**Town of Kittery Maine
 Planning Board Meeting
 May 23, 2019**

ITEM 3 - 12 Haley Road – Shoreland Development Plan Review.

Re: Revised - Shoreland Development Plan Submission
Applicant: Kimberly Lingard, 12 Haley Road, Kittery, ME
Job No. 19-113

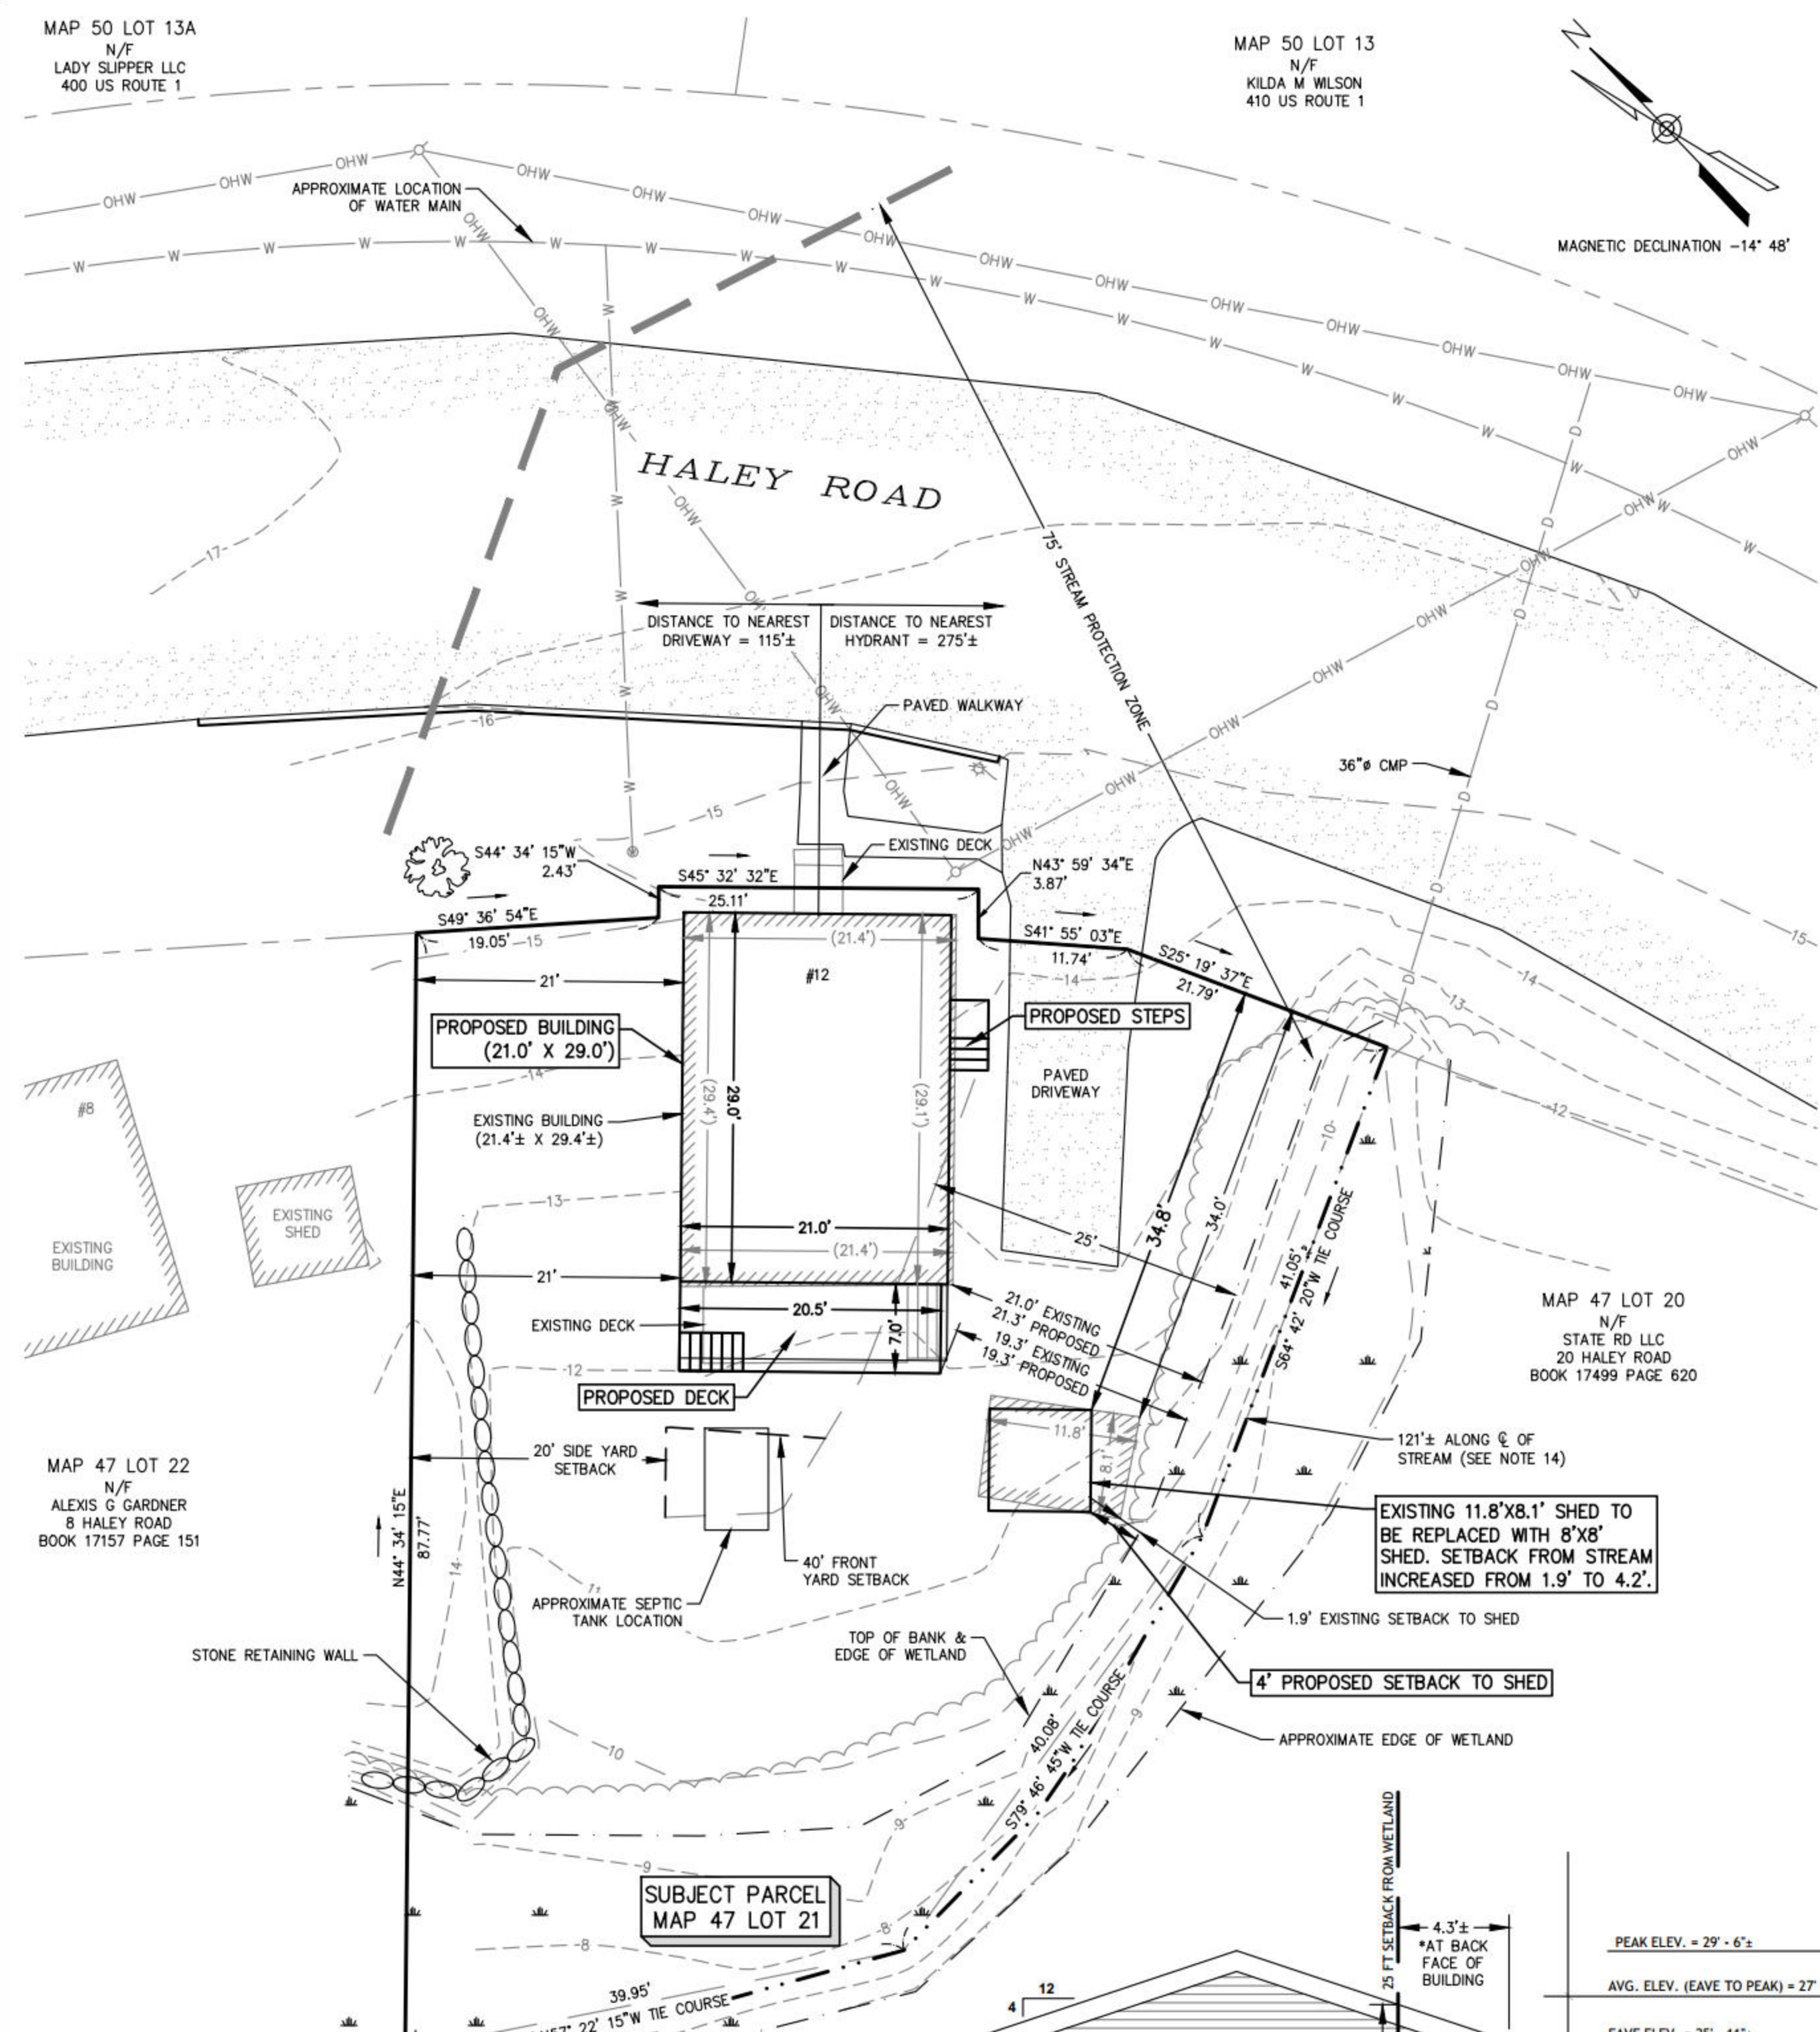
The Kittery Land Use and Development Code defines “expansion” as *an increase in the floor area or volume of a structure, including all extensions, such as, but not limited to, piers or attached decks, garages, porches and greenhouses.* As the proposed building is smaller in footprint than the existing building, there is no increase in area. The proposed building does have a steeper roof than the existing building; therefore the Planning Board has requested that volume calculations be provided to demonstrate compliance with 16.7.3.3.2.E.2.

Since the Kittery Land Use and Development Code does not specify the lower limit surface to use as the baseline for the volume calculations, we have decided to provide the volume calculations using three different baselines. 1) crawlspace floor elevation 2) average ground elevation and 3) first floor elevation.

For all three scenarios, the volume of the proposed structure was found to be less than the volume of the existing structure, for the portion within 25 feet of the wetland. Although increasing the pitch of the roof does add volume to the structure, it is offset by the reduction in volume due to the proposed structure being located further away from the wetland.

It is therefore concluded that the proposed structure does not result in an increase in area or volume compared to the original structure as required by Section 16.7.3.3.2.E.2.

SHORELAND DEVELOPMENT PLAN
FOR LAND LOCATED AT
12 HALEY ROAD, KITTERY, MAINE

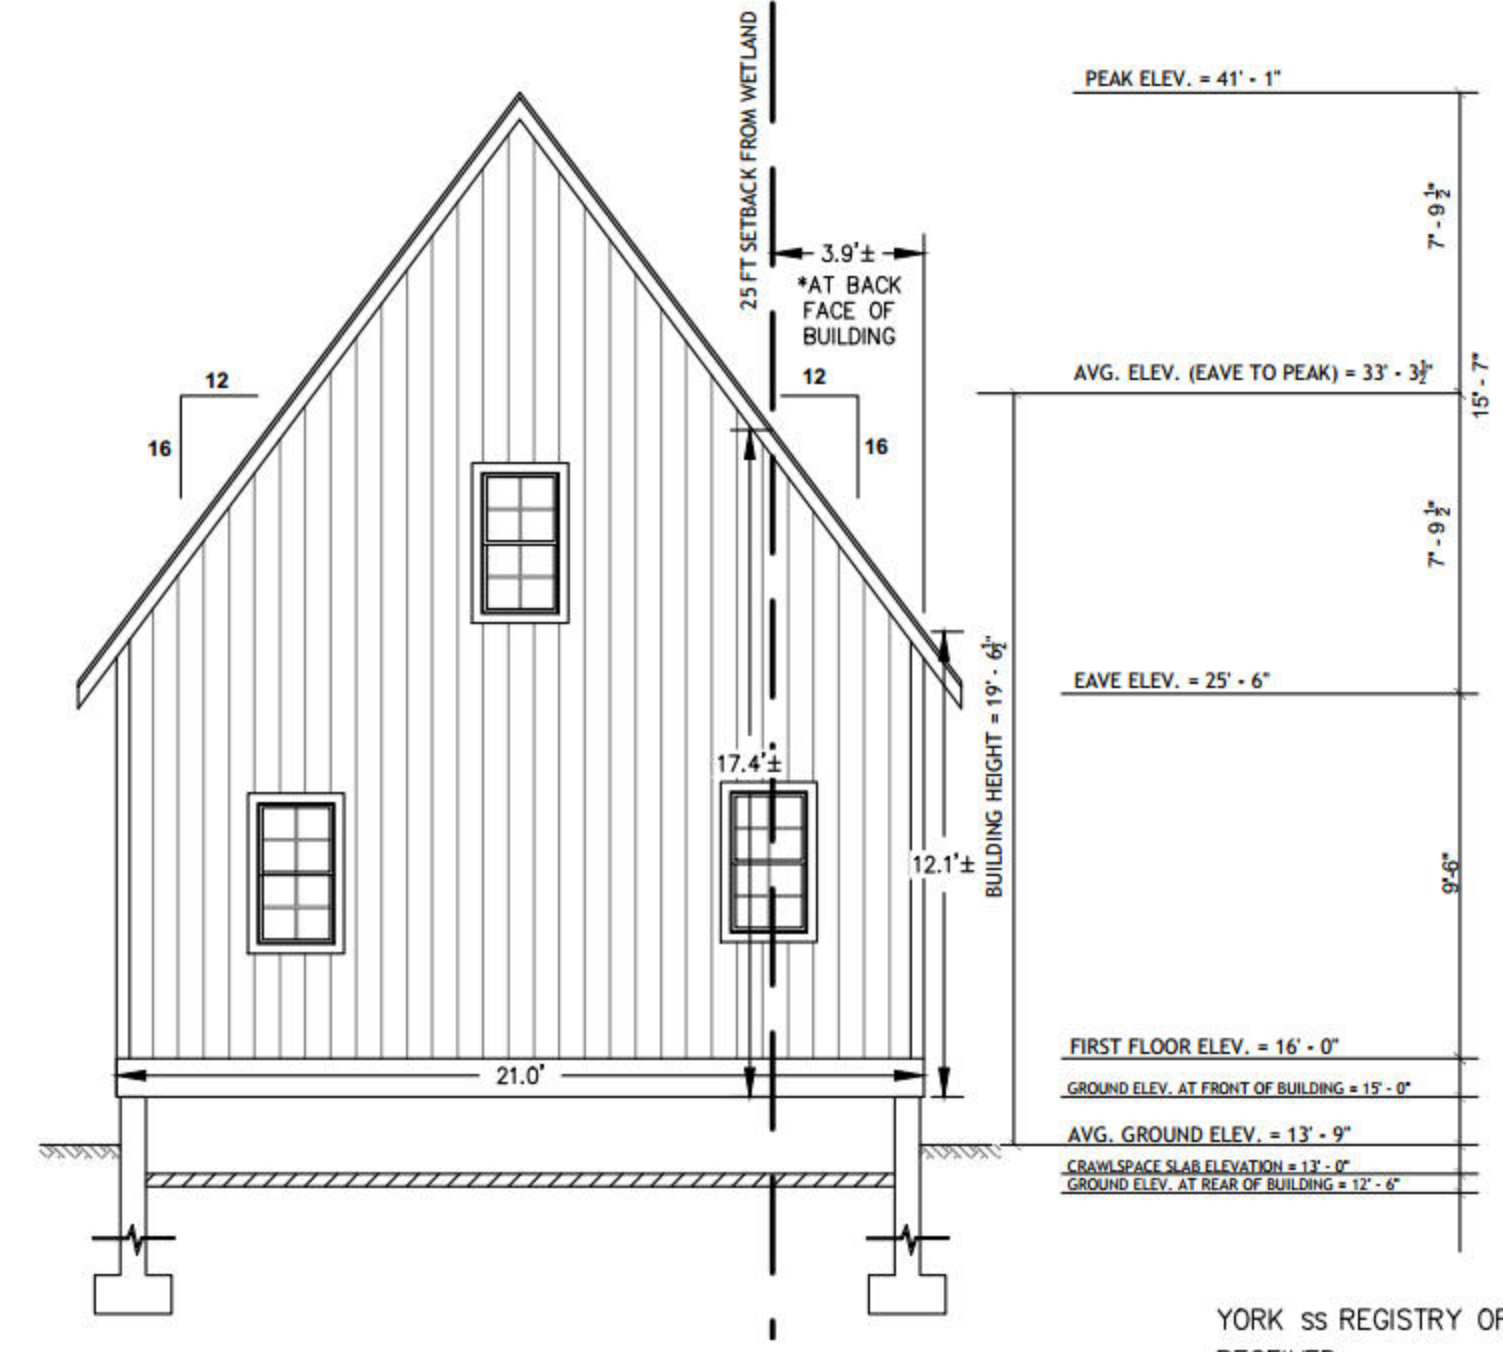
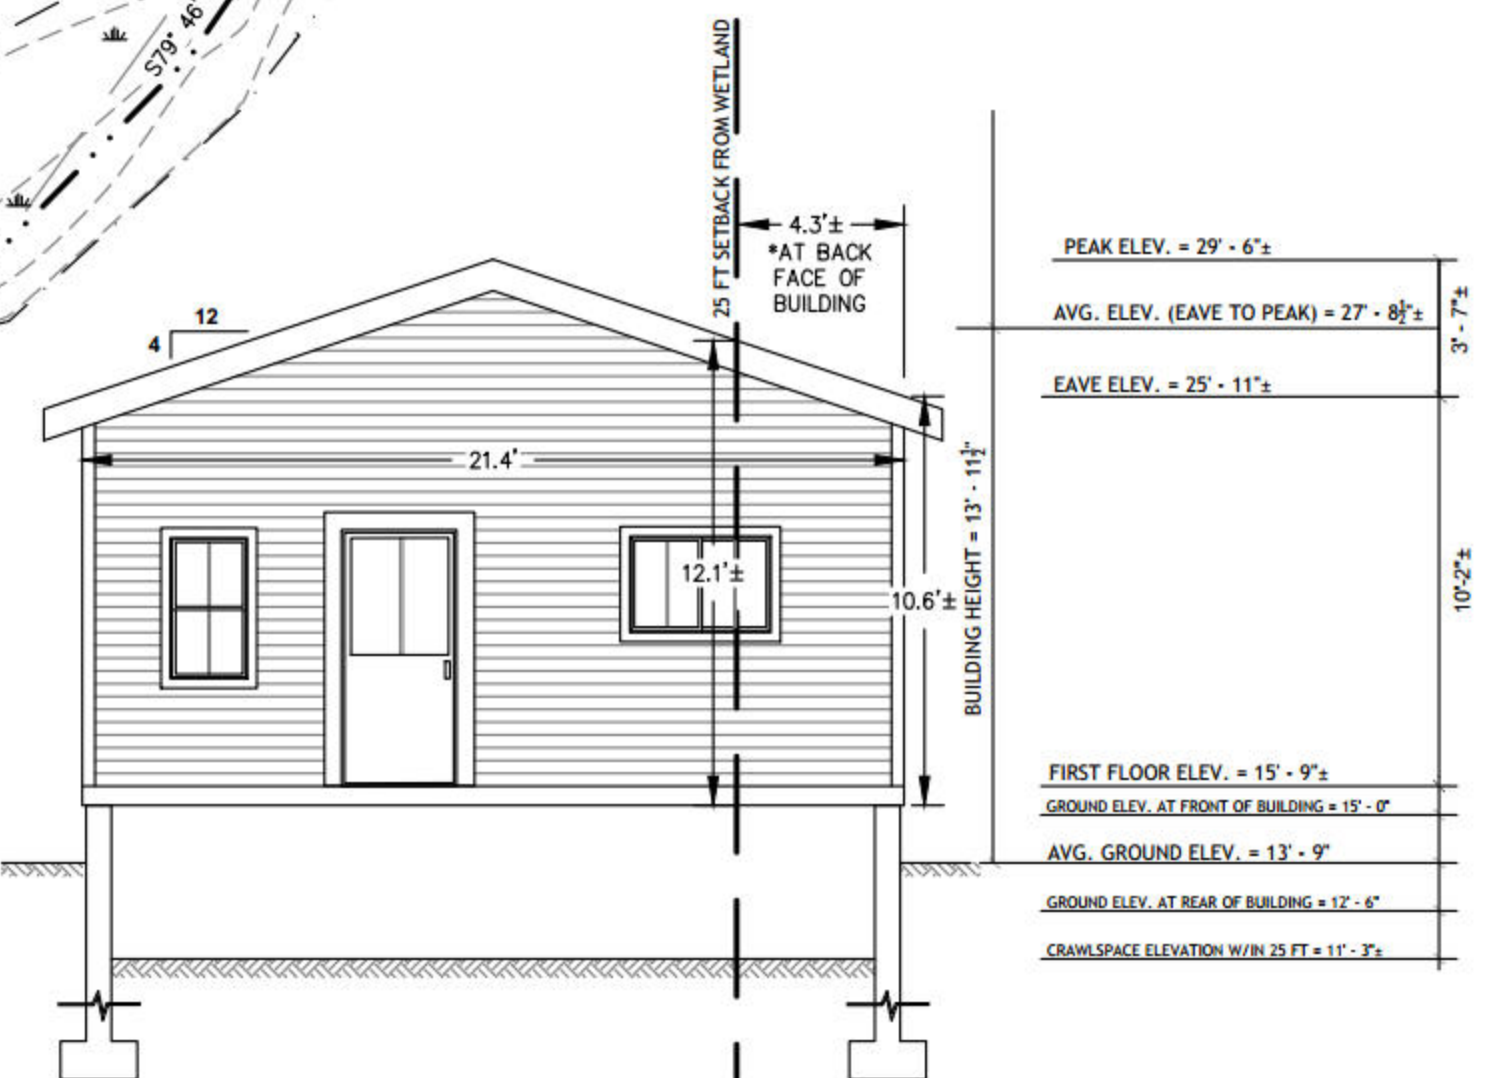
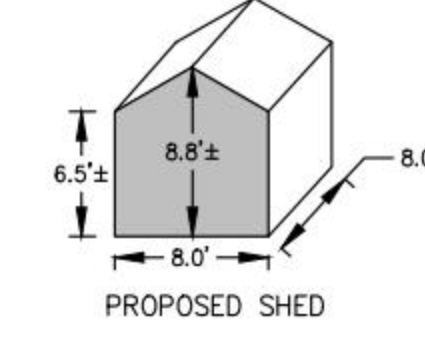
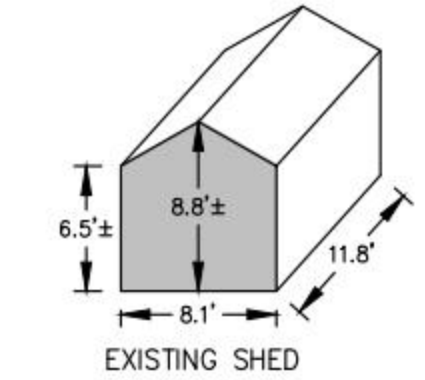
- b. Per Section 6.3.2.17.D (Shoreland Overlay Zone, Standards) the total footprint of the devegetated area cannot exceed 20%. The property is currently non-conforming with about 28.1% devegetated. As outlined on the Shoreland Development Plan with the proposed improvements the devegetated area will remain at 28.1%. See the Existing and Proposed Devegetated Coverage Calculations on the plan for details.

Per Section 16.3.2.1 D. (e) the maximum building coverage for the zone is 15%. The existing condition is at 18.8% and with the proposed improvements the building coverage will decrease by approximately 0.3%.

1. Shoreland Development Plan – Revision 1
 - a. Proposed Shed: Footprint reduced from 11.8' x 8.1' to 8' x 8'. This further improved the non-conforming setback from the wetland/stream and the front property line. Also added a dimension labeling the existing and proposed distance from the front property line.

- b. Proposed Deck: Modified the overall dimensions and configuration to incorporate the steps within the rectangular deck area instead of the steps extending off the deck into the backyard. The proposed deck maintains the same existing setback to the wetland/stream and side property line.

- c. Proposed Building Elevation View:
 - i. Lowered the first floor elevation four inches. This reduces the proposed building height by four inches as well.

- ii. Added the proposed crawlspace.
 - iii. Added the 25ft setback line from the wetland.
 - d. Existing Building Elevation View:
 - i. Recreated an elevation view of the existing structure based upon field evidence and photos of the building prior to demolition. A detailed explanation of how this was recreated is enclosed.

- iv. Portion of Structures Within 25 ft of Wetland – Added comparison of the existing/proposed area and volume of the structures within 25 feet of the wetland to demonstrate compliance with Section 16.7.3.3.2.E.2 that prohibits expansion of any portion of a structure that is located within 25 feet of the wetland. A detailed explanation of how the volume was calculated is enclosed.
2. Supplemental Narrative
 - a. Explanation of existing structure regeneration.
 - b. Explanation of building volume calculations.
